Appendix F:

## **Hydrology and Water Quality Supporting Information**

# STORMWATER CONTROL PLAN FOR A REGULATED PROJECT

## Appendix B – Response to June 9, 2021 comments received from River Focus Water Resources Consultants.

Figure A2: Surveyed elevations in the vicinity of the houses located downstream of the proposed project on the south side of Salvador Creek (the existing and proposed 100-yr water surface elevations in this reach are 68.1 and 68.2 ft respectively).

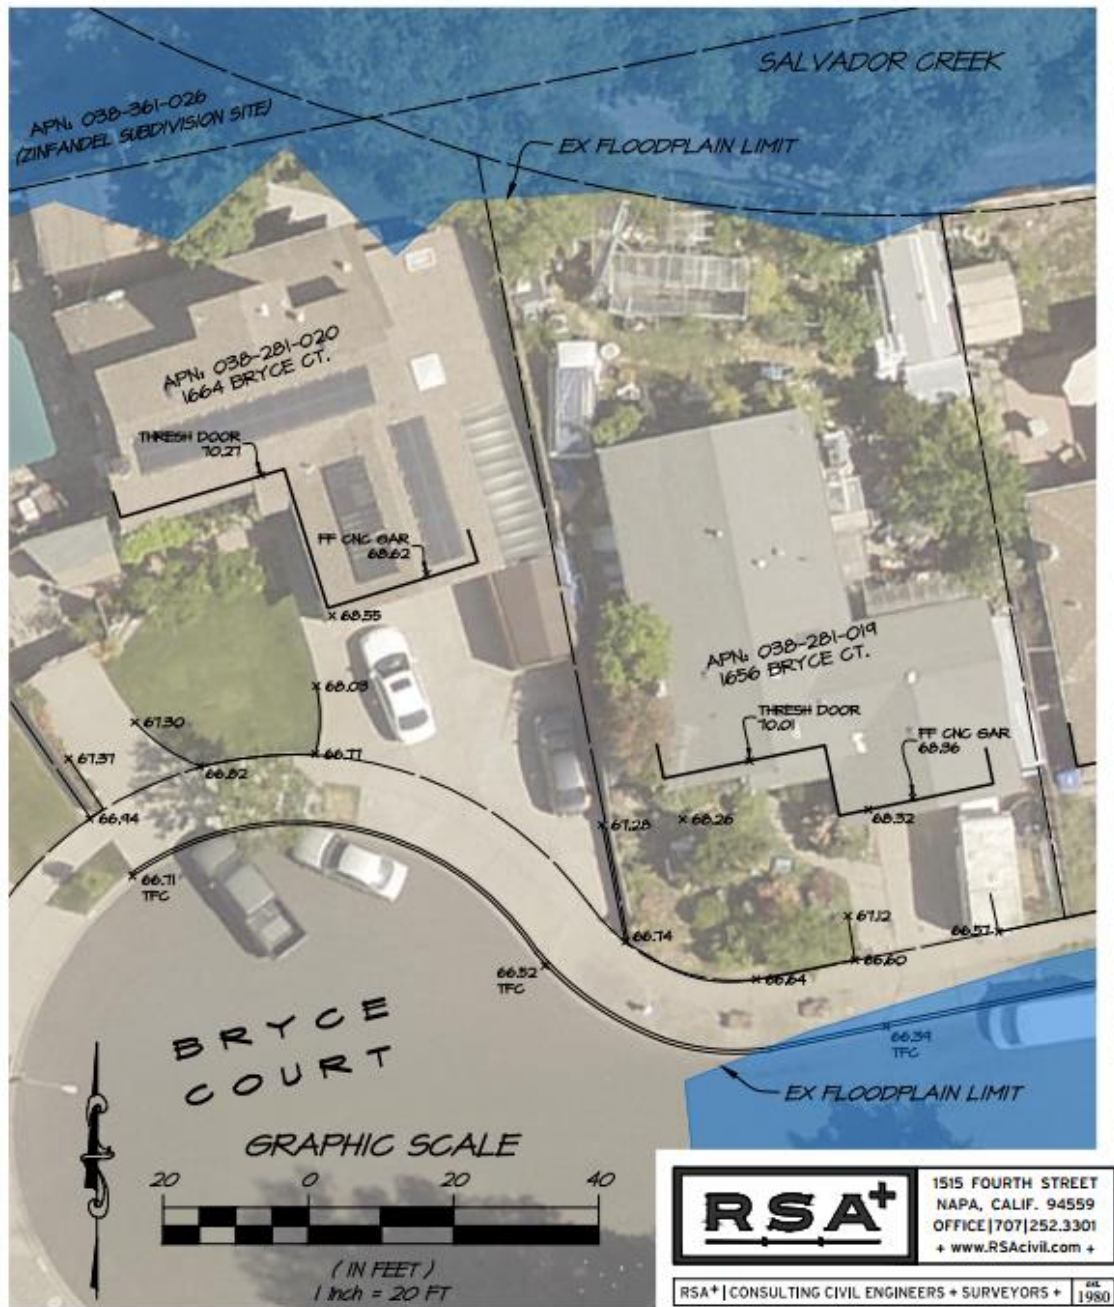
3. For Alternatives 2 and 3, it is difficult to determine whether the floodplain benefits outweigh the areas where flood depths are increasing. This is because not all increases (and decreases) are alike. For example, flood depth increases on undeveloped land may be more acceptable than increases affecting existing structures. For each recurrence interval event, please provide a comparison of:
  - a) The number of insurable structures and the total floodplain area with WSE increases greater than 0.1 ft; and
  - b) The number of insurable structures and the total floodplain area with WSE decreases less than 0.1 ft.

The table below provides the requested information for Alternative 2. As discussed above in the response to item #2, Alternative 3 has been removed from consideration due to unacceptable impacts. Changes in floodplain inundation on the proposed project parcels were excluded from the tabulation of floodplain area change to avoid skewing the results. The proposed condition results in reductions in offsite floodplain inundation area for all three flood events. The number of structures with decreases in WSE is greater than the number of structures with increases for all three flood events. The raw model outputs do indicate increases in 100-yr WSEs greater than 0.1 ft in the vicinity of two houses, however additional surveying and more detailed floodplain mapping was performed in the vicinity of the houses which revealed that the finished floor elevations are above both the existing and proposed 100-yr WSEs, therefore these structures were excluded from the table. The detailed mapping for the house upstream of the project on the north bank is discussed above under Item #1 and presented in Figure A1, and the detailed mapping for the other house downstream of the project on the south bank is presented in Figure A2. These statistics clearly show that the project results in a net reduction in flood risk to the surrounding neighborhoods.

Figure A5: Proposed velocities for the 10-yr (top) and 100-yr (bottom) floods.

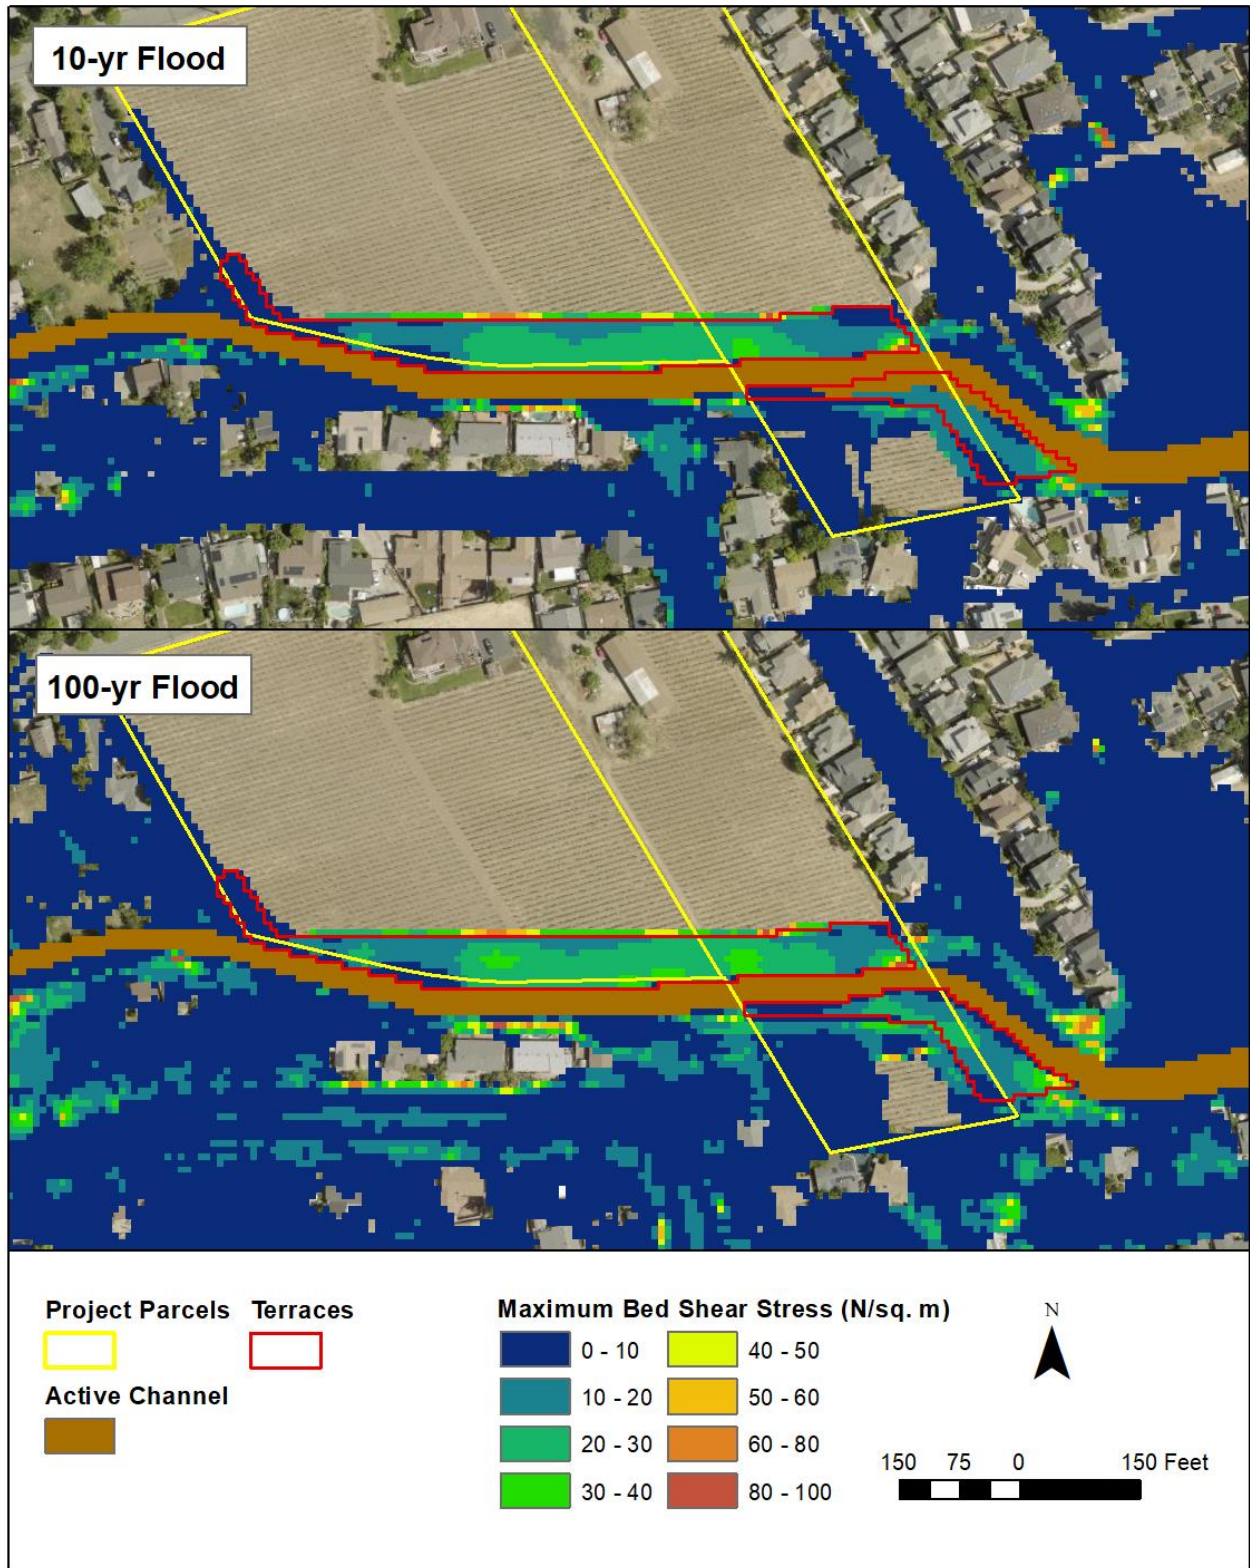
8. Please provide velocity and shear stress results for the terraces and fill slopes along the terraces and verify that no additional protection is required.

The requested results are provided below in Figures A5 & A6. Maximum velocities and shear stresses on the terraces are ~2.3 fps and 35 N/m<sup>2</sup> respectively. These values indicate that additional protection beyond the planned planting of native grasses, shrubs, and trees is not necessary. Maximum velocities and shear stresses on the side slopes leading down to the terraces are ~7.2 fps and 100 N/m<sup>2</sup> respectively. These values indicate that these fill slopes do require additional protection in the form of 9-in d<sub>50</sub> or larger rock rip-rap which will be incorporated in the final design plans.
